## COUNCIL ASSESSMENT REPORT

<b>Panel Reference</b>	2016HCC014
<b>DA Number</b>	DA/202/2016
<b>LGA</b>	Lake Macquarie
<b>Proposed Development</b>	Residential Aged Care Facility
<b>Street Address</b>	Lot 11 DP 656806, Lot 1 DP 515152, Lot 2 DP 515152, Lot 3 DP 515152, Lot 4 DP 515152  64 Warners Bay Road, WARNERS BAY NSW 2282, 66 Warners Bay Road, WARNERS BAY NSW 2282, 68 Warners Bay Road, WARNERS BAY NSW 2282, 70 Warners Bay Road, WARNERS BAY NSW 2282, 72 Warners Bay Road, WARNERS BAY NSW 2282
<b>Applicant/Owner</b>	BUPA CARE SERVICES PTY LIMITED
<b>Date of DA lodgement</b>	15 February 2016
<b>Number of Submissions</b>	Two
<b>Recommendation</b>	Approval
<b>Regional Development Criteria (Schedule 4A of the EP&amp;A Act)</b>	General development over \$20 million
<b>List of all relevant s79C(1)(a) matters</b>	<ul style="list-style-type: none"> <li>• Lake Macquarie Local Environmental Plan 2014</li> <li>• Lake Macquarie Development Control Plan 2014</li> </ul>

# Assessment Report and Recommendation

**Figure 6:** Riparian Zone building encroachment

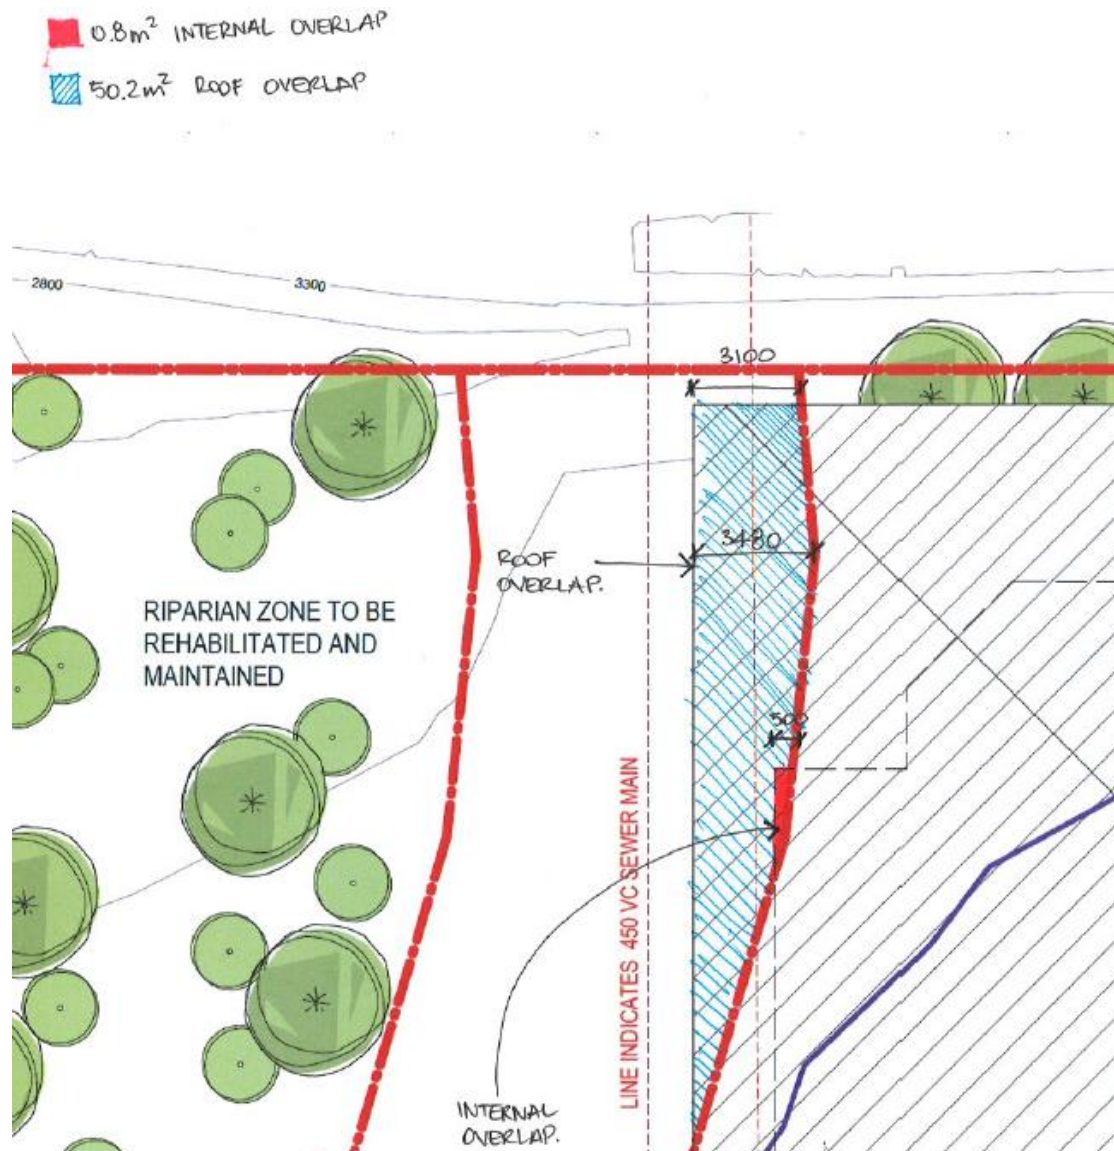
The building is set back 30m from the riparian zone, with a minor encroachment for the rear north-western corner of the building, upper level balconies and roof overhang (see below), which is considered to be negligible and acceptable on merit.

**Figure 7: Signage Location Plan**

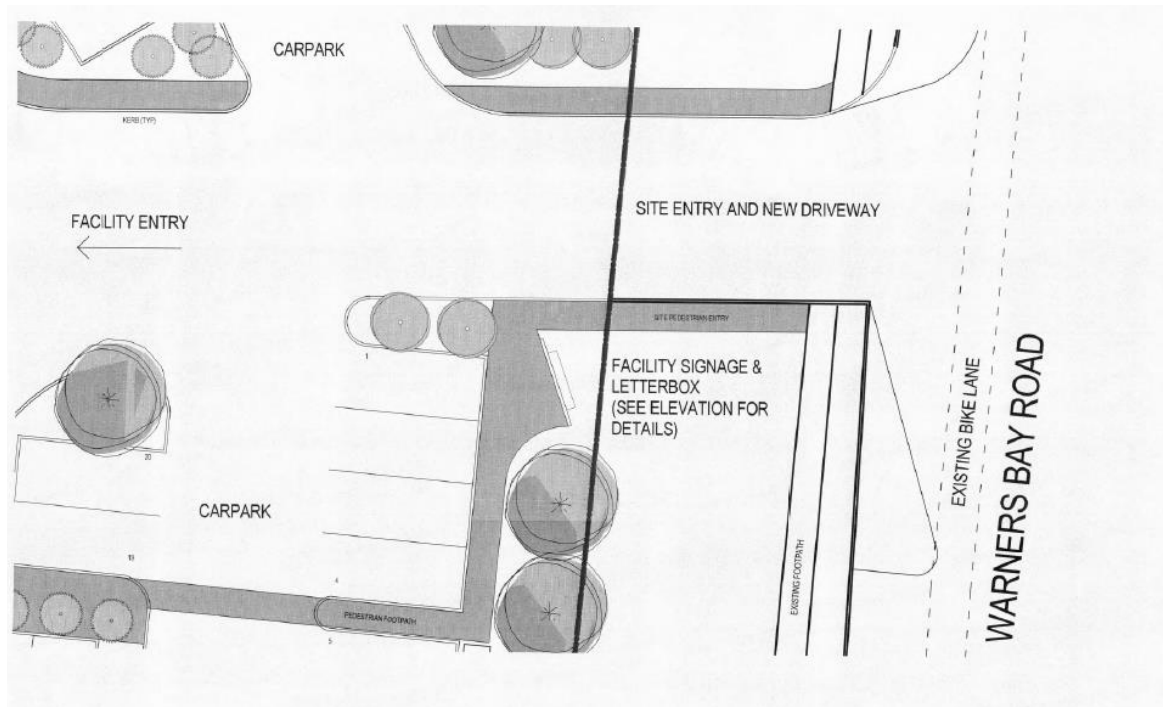
The proposal includes an entry signage panel to the site frontage, comprising a 1.75m high (3.47m long) masonry wall panel (off-form concrete finish) to incorporate an aluminium building identification sign, mailbox for the facility and a face brickwork planter box feature.

The signage panel/entry feature is located adjacent to the vegetated buffer and carparking area at the front of the site.

The maximum height of the signage above ground is 1.75m, which is considered appropriate to provide for adequate identification of the premises and to not negatively detract from the amenity of the area.

**Figure 10:** Extract from Lake Macquarie LEP2014 height of buildings map

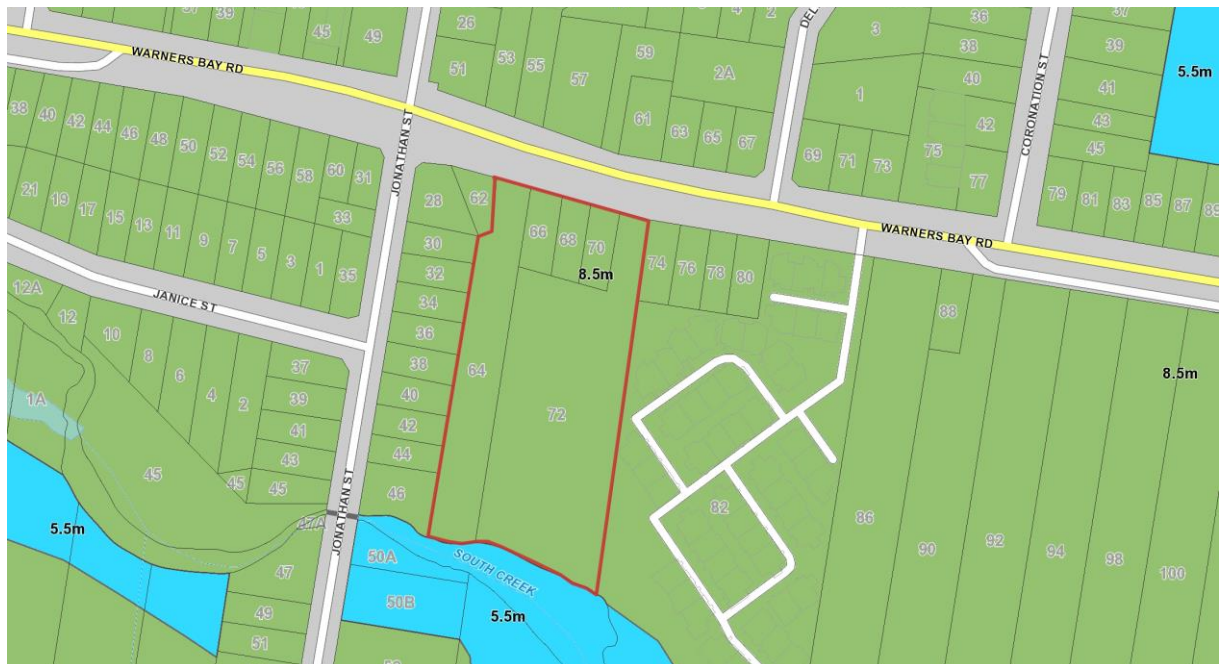
The main building that comprises the proposed residential care facility exceeds the maximum 8.5m height (from natural ground level) for land shown on the *Height of Buildings Map*.

The non-compliance relates primarily to the rear portion of the proposed building, with the maximum height reached being 10.5m at the south-western corner. The building is predominantly two storeys in height although the rear of the building, located where the site slopes down to the south-west, is cantilevered over an undercroft area in order to achieve the ground floor level of the building required to address the 1:100 year flood levels for the site.

A non-compliance with the maximum height control also applies to the central pitched roof section of the building, which extends from the entry canopy at the front to approximately one third of the building length (including a rooftop mechanical plant enclosure). This roof plane is restricted to the centre of the site, set well back from the edges of the main roof, adds visual interest to the design, improves the contribution of the building to the streetscape and does not result in amenity impacts to adjacent properties.

The Clause 4.6 exception adequately addresses the reasons for the contravention and identifies sufficient environmental planning grounds to justify that the compliance with the development standard is unreasonable and unnecessary, given the circumstances of the case and the existing site constraints.

**Figure 11: Measures to minimise potential inundation to adjacent sites**

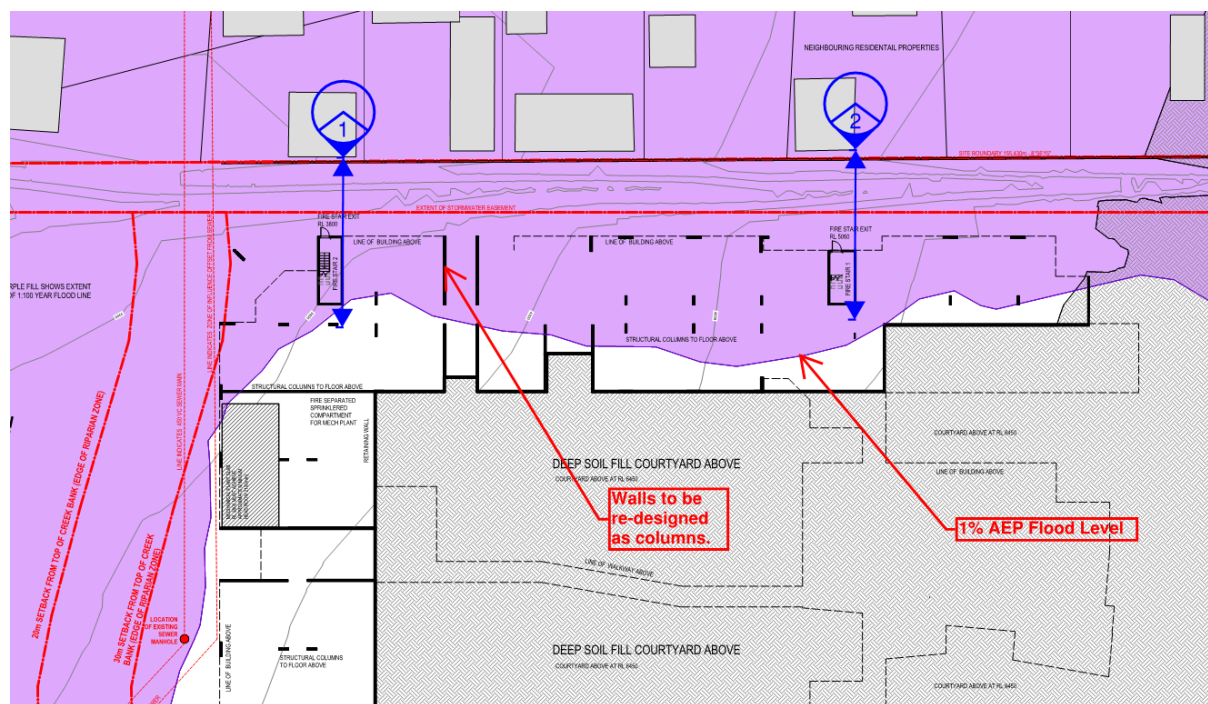
*“To further assess the impact of the development footprint on the 1% AEP flows from the western catchment, cross-sections of the flow path have been taken at two locations where the building impediment is at its greatest..”*

*“Noting that the walls highlight in Figure 1 will be redesigned as columns, the only prominent obstructions proposed within the western 1% AEP flow path are the Fire Stairs. These stairwell structures are 2.8m wide and 7.4m and 5.8m long respectively at Sections 1 and 2. As shown in Attachment 1, the depth of flow at both proposed stair locations does not exceed 100mm and is located at its outer extents. Given this the impact of the stairwells on flooding depths is expected to be minimal. However, to offset the loss of capacity it is proposed that compensatory volume be provided by lowering the channel adjacent to the stairs as depicted in flood storage cross sections. The provision of compensatory capacity in the channel will more than offset the impact of the isolated obstructions and avoid any impact to flood levels.*”

*Egress paths are also proposed from this area of the building. The location of the paths is shown in Figure 2. The pathway is to follow the natural contours along the western boundary and avoid the use of fill to minimise any impact to flood levels. In addition the link bridges shown traversing the drainage channel are to be suspended above the 1% AEP flood level and be designed as removable grate crossings to allow clear access for maintenance.*

**Figure 13:** Extract from Noise Assessment Report – Recommended acoustic fencing to side boundaries of front setback

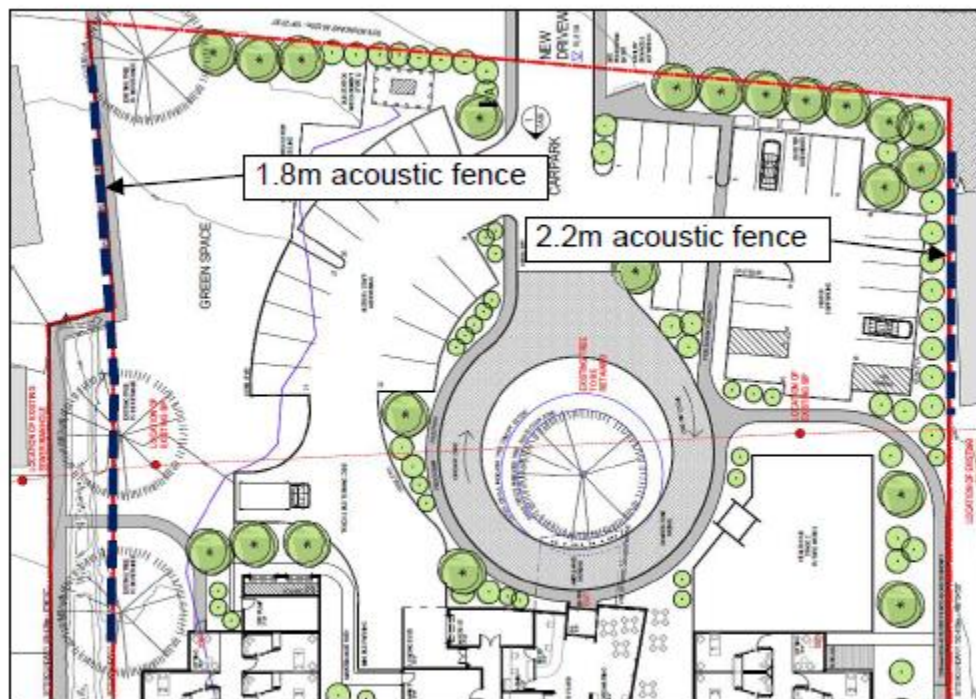
- Acoustic barrier be provided to the carpark on the eastern side of the front setback to a height of 2.2m.
- Acoustic barrier be provided to the western side of the front setback to a height of 1.8m.
- The Acoustic barriers comprise a fence containing no holes or gaps and makes contact with the ground and has a mass of at least 15kg/m<sup>2</sup> (ie, lapped and capped palings or Hebel panels).
- Provide appropriate noise screening to mechanical plant enclosure at the rear of the development. For sound power level up to 80 dB(A) this would comprise a 9mm fibre cement screen, or should the total sound power level of the plant exceed 80 dB(A) the enclosure would need to be roofed and have solid walls, essentially making it a plant room.

The recommendations of the Acoustic Report in regards to acoustic fencing provision to both sides of front setback (to be located on respective boundaries) and screening of plant enclosure to rear are included in a recommended condition to the determination, should the application be approved.
